LiDAR Quality Assurance (QA) Final Report
Sub-Project 3: North Central Kansas
Nebraska/Kansas LiDAR
December 31, 2009

Submitted to:
USDA-NRCS-Nebraska/
U.S. Army Corps of Engineers

Prepared by:
 **Dewberry**
Fairfax, VA

Figure 8: tile 14S PK 1010 showing a building in the ground surface

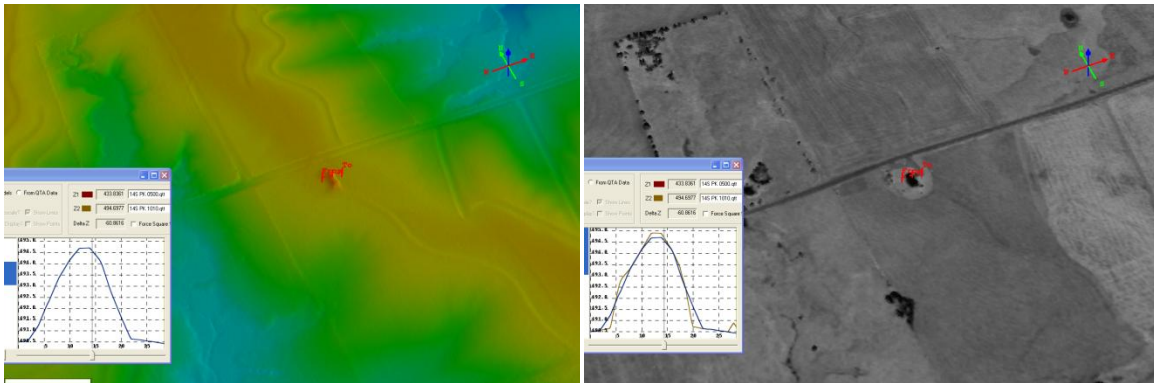
While reviewing the dataset, several buildings were found classified as ground. There is a 2% allowance for building artifacts; therefore these errors do not need to be reprocessed. Figure 8 shows the building remaining in the ground classification. The image on the right shows the full point cloud colored by intensity and the model on the left shows the ground classification colored by elevation. The profile graph shows the elevation difference between the full point cloud and ground. Please see section 7.1 for screenshot thumbnails.

Figure 9: tile 14S PK 4520 showing vegetation in the ground surface

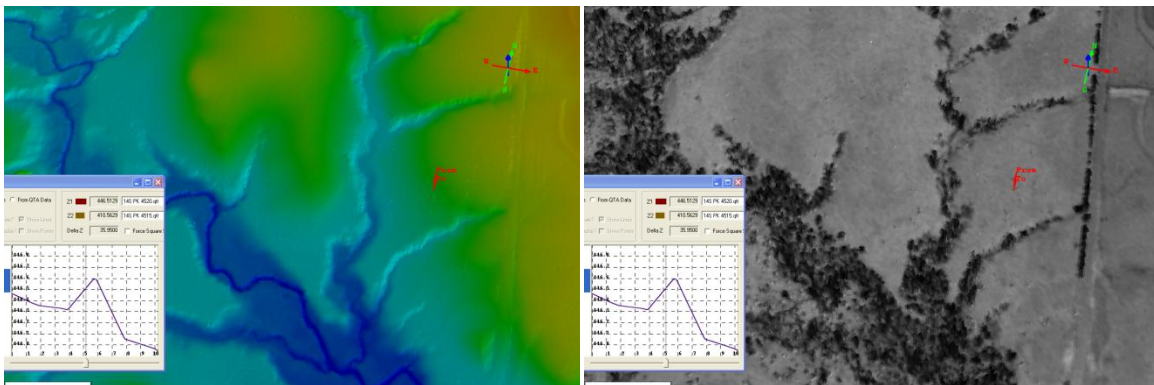
Dewberry also identified one case of vegetation remaining in the ground classification. There is a 5% allowance for vegetation in the project area so this error does not need to be reprocessed. Figure 9 shows the full point cloud colored by intensity on the right and the ground classification colored by elevation on the left. The profile graph shows the height of the artifact in the ground model. Please see section 7.1 for screenshot thumbnails.

Figure 10: tile 14S PK 4515 showing low density due to point spreading

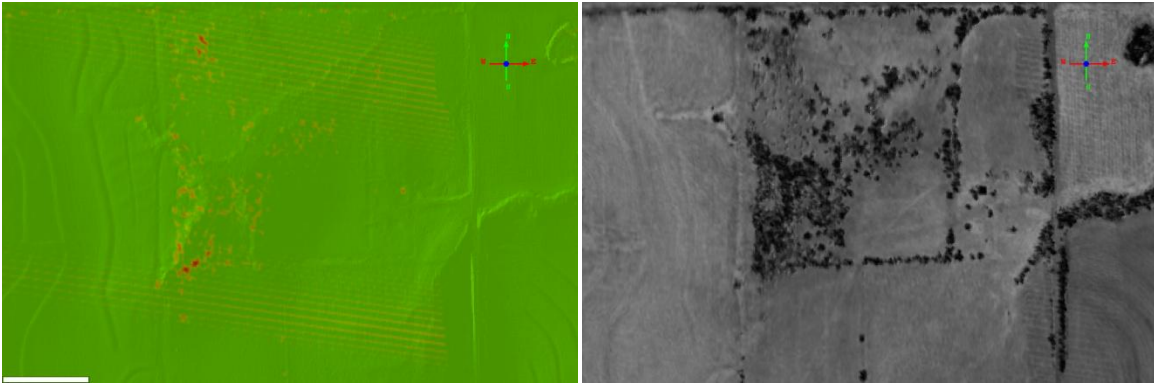
Dewberry identified several areas of the dataset with slightly uneven point spacing. The adjacent flight lines appear to diverge and converge, usually due to sudden changes in atmospheric conditions such as wind. This point spreading is somewhat visible in the high density models in Figure 10 and Figure 11. Since this issue affects the full point cloud there is no densification that will correct the error, but the points are not spread apart to cause a problem in modeling or analysis. Please see section 7.2 for screenshot thumbnails.

Figure 12: tile 14S PJ 0590 showing noise in the flight line overlap area

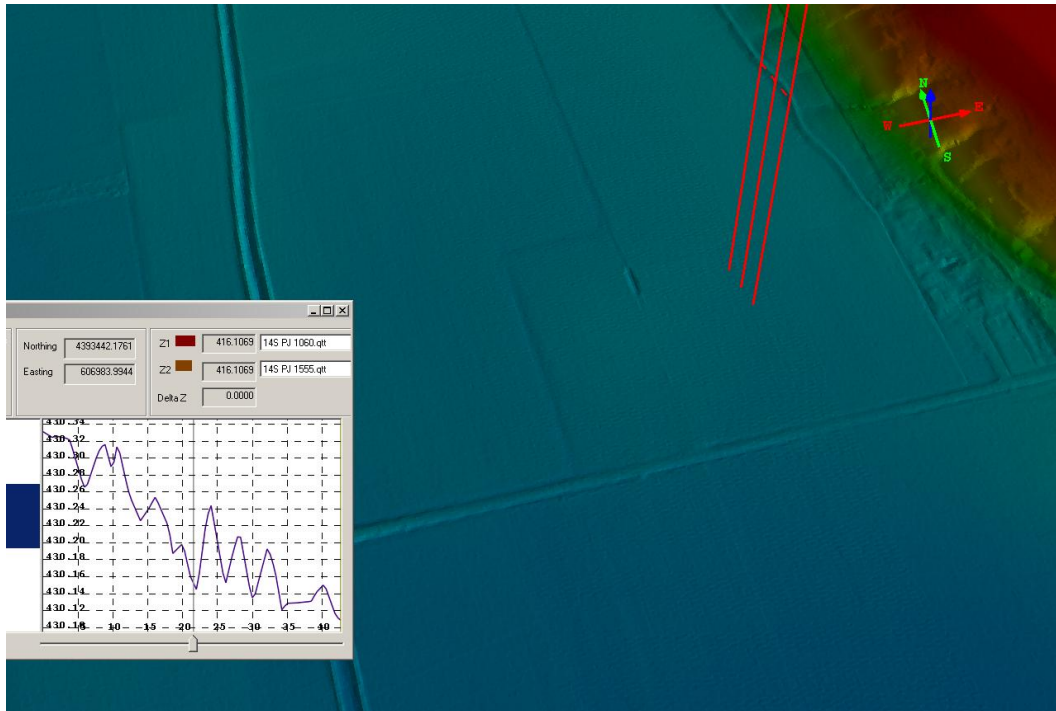
Noise due to small elevation differences between flight lines is a minor error found throughout the dataset. In areas where two or more flight lines overlap, the ground model appears more rough (noisy), as illustrated in Figure 12. All the noisy areas had elevation differences between flight lines of less than 20cm, which is relatively minor and should not affect the usability of the data. Please see section 7.3 for screenshot thumbnails.
